SERVICE BULLETIN

Bulletin No. SVB-129

Model SE & ME

Subject Port Timing Mod.

PORT TIMING MOD. FOR SE & ME MODEL MOTORCYCLE

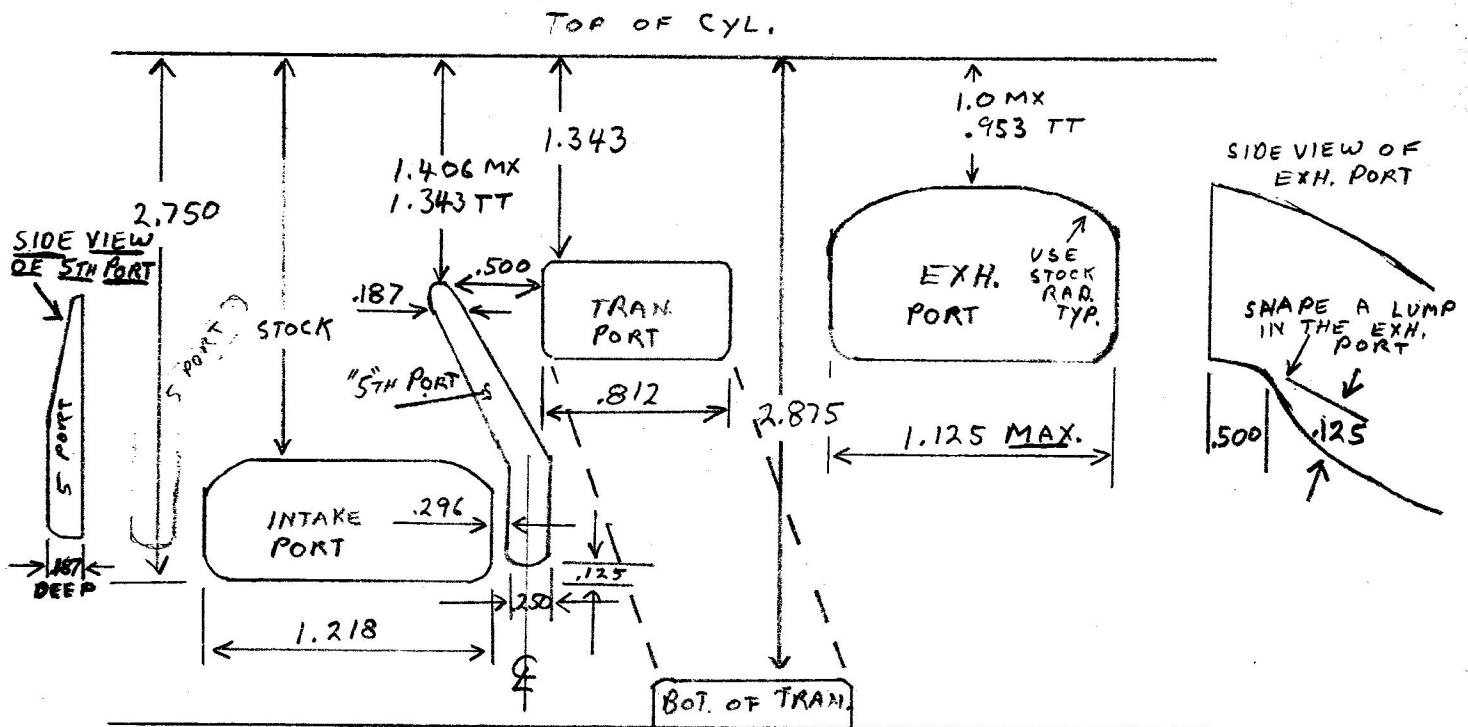
- NOTE:
- ① DRILL $\frac{1}{4}$ " HOLES ON THE ϕ OF THE "S" PORT GROVES, $\frac{9}{16}$ " FROM THE TOP OF THE PISTON (2 HOLES IN PISTON)
 - ② MX DIM. = MOTOR CROSS
 - ③ TT DIM. = FLAT TRACK
 - ④ CUT .060 OFF THE INTAKE SKIRT OF A STOCK PISTON FOR "MX"
 - ⑤ CUT .125 OFF THE INTAKE SKIRT OF A STOCK PISTON FOR "TT"
 - ⑥ CHAMFER ALL EDGES
 - ⑦ DO NOT CUT INTAKE SKIRT OF RACING PISTON
 - ⑧ MUST USE ALL OTHER H.P. PARTS OF INDIAN SE, ME-74-76/KIT
